COUNCIL ASSESSMENT REPORT

Panel Reference	2016SYE083
DA Number	DA-2017/27
LGA	Bayside Council
Proposed Development	Integrated Development - Construction of a part three (3) and part four (4) storey residential care facility comprising 198 sole occupancy rooms including amenity, services and car parking within two (2) levels of basement, chapel, function room, roof top communal open space, vegetable garden, putting green and demolition of existing structures
Street Address	62-82 Harrow Road Bexley
Applicant/Owner	St Basils Homes
Date of DA lodgement	26 July 2016
Number of Submissions	Nine (9) submissions received following the original notification. Four (4) received following re-notification of amended plans. Total of thirteen (13) submissions.
Recommendation	Approval subject to conditions
Regional Development Criteria (Schedule 4A of the EP&A Act)	CIV >\$20 million
List of all relevant s79C(1)(a) matters	S91A – EP&A Act 1979 (as amended) SEPP Infrastructure 2007 SEPP (Infrastructure) Amendment (Review) 2016 SEPP (Major Development) 2005 SEPP 55 – Remediation of Land Rockdale LEP 2011 Rockdale LEP Amendment 13 Rockdale DCP 2011 EPA Regulations 92, 98A and 98E Section 94 Developmen

Figure 9 - Height as proposed

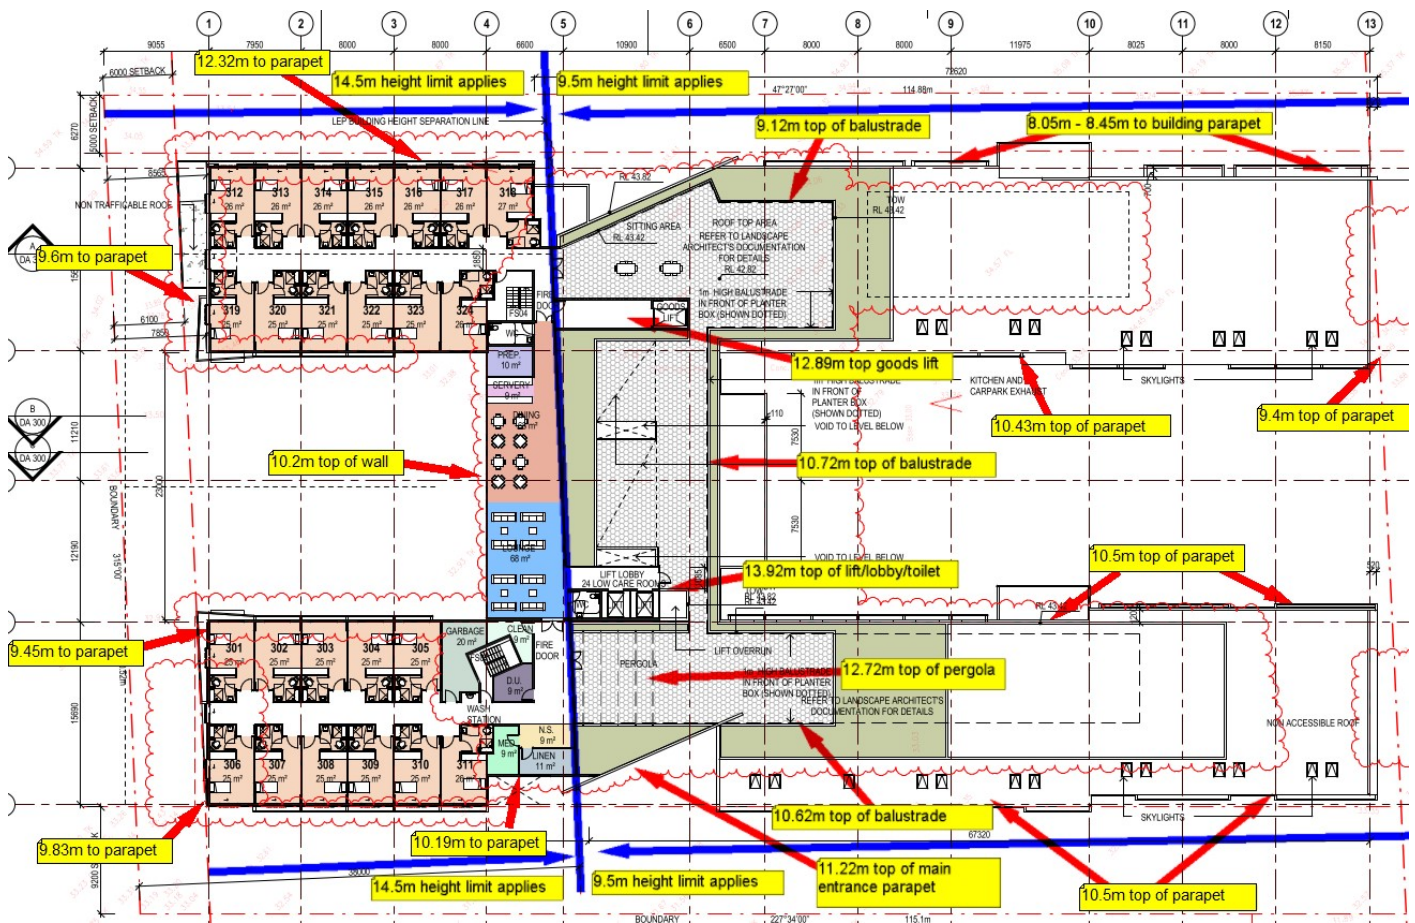
- j) Top of parapet above main entrance to building 11.22m (1.72m height variation)
- i) Top of pergola at communal rooftop terrace - 12.72m (3.22m height variation)

As can be seen above, the proposal partially complies with the 9.5m height limit to the parapet of the building and balustrade at rooftop level along the Bowlers Avenue wing of the development. The proposal however penetrates the 9.5m height limit in various locations on the site as detailed above and illustrated in the image below. The variation to the height limit as proposed is 1m - 4.42m which equates to 10.5% - 46.5%.

The applicant has submitted a clause 4.6 variation to development standard in relation to the proposed above exceedance. The above has been addressed within Clause 4.6 of this report.

Figure 13 - Fencing illustrated by blue line

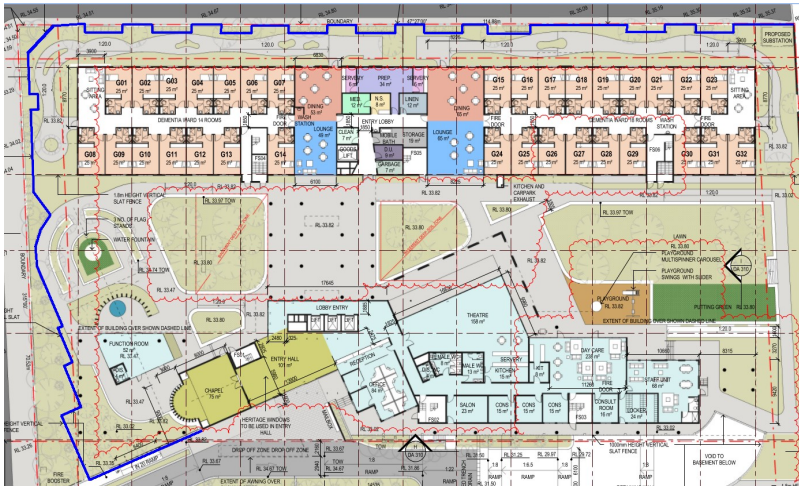
The 1.8m high front boundary fencing to Bowlers Avenue is stepped along this boundary of the site, with screen planting proposed in front of the fencing at intervals. Screen planting comprises trees and shrubs capable of growing to a mature height from 0.3m to 8m. i.e. Dwarf gardenia / blueberry ash. It is important to note that the height of boundary fencing in this location is directly correlated to the use of the front setback of the site as a landscaped communal strolling area for dementia patients.

Whilst the screen planting proposed has the ability to partially obscure the 1.8m high fence, the provision of fencing to a height of 1.2m in this location would be more appropriate given the low front boundary fencing that exists within the Bowlers Avenue streetscape. Given the aforementioned, due consideration has also been given to the security of dementia patients likely to occupy the front setback of the site to bowlers avenue. It is noted that the dementia strolling path comprises a level of 33.82RL, this is 0.68m - 1.5m below the existing footpath level along Bowlers Avenue. The addition of a 1.2m high fence in lieu of a 1.8m high fence as proposed, would ensure that a minimum fence height of 1.8m is provided above the dementia strolling path to ensure the security of future patients.

Figure 14 - Shadow impacts midwinter

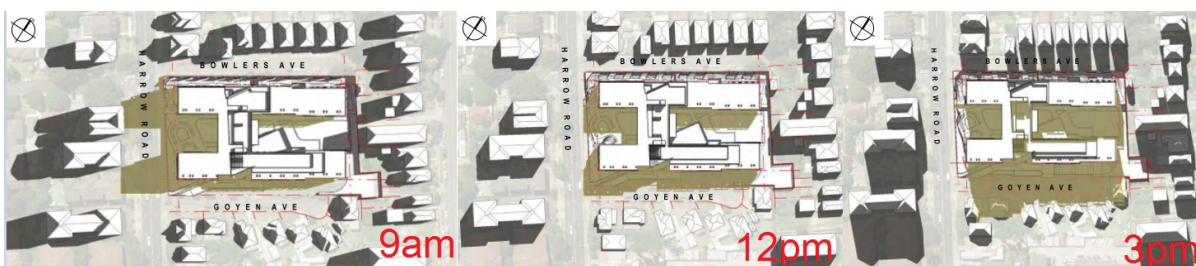
As can be seen above, properties within Bowlers Avenue are located to the north / north west of the subject site. The proposed development does not generate shadows onto these properties given this orientation.

Figure 18 - Proposed vertically positioned hydrant pipes

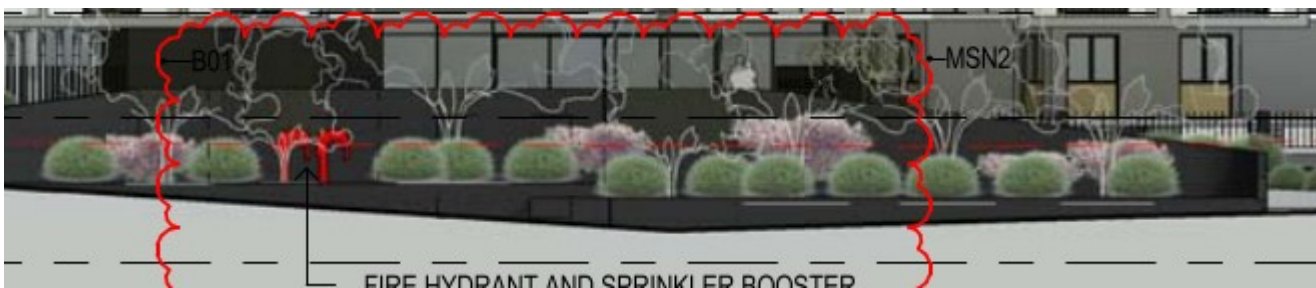
Plans illustrate the provision of vertically positioned pipework for the fire booster / hydrant located within the planter bed proposed to be provided along the Goyen Ave frontage of the site. The proposed pipework is discretely located amongst the landscaping and is considered to be located appropriately on site. The proposal is satisfactory in relation to the provisions of this clause.

Figure 18 - Proposed pedestrian pathway along Goyen Avenue

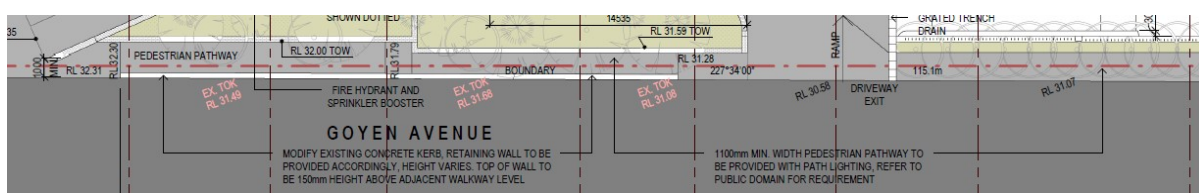
No footpath proposed to Goyen and Bowlers Avenues

Comment: Plans indicate that the existing 1m wide pedestrian pathway along the Bowlers Avenue frontage of the site is to be retained, this is deemed to be satisfactory. The main entrance to the proposed aged care facility is from Goyen Avenue. Appropriate pedestrian access is provided from the public domain to the main entrance of the facility in the form of a ramp which acts as an extension of the public footpath at the junction of Harrow Road and Goyen Avenue. Additionally a 1.1m wide pedestrian pathway is proposed along the periphery of the Goyen Avenue frontage of the site.
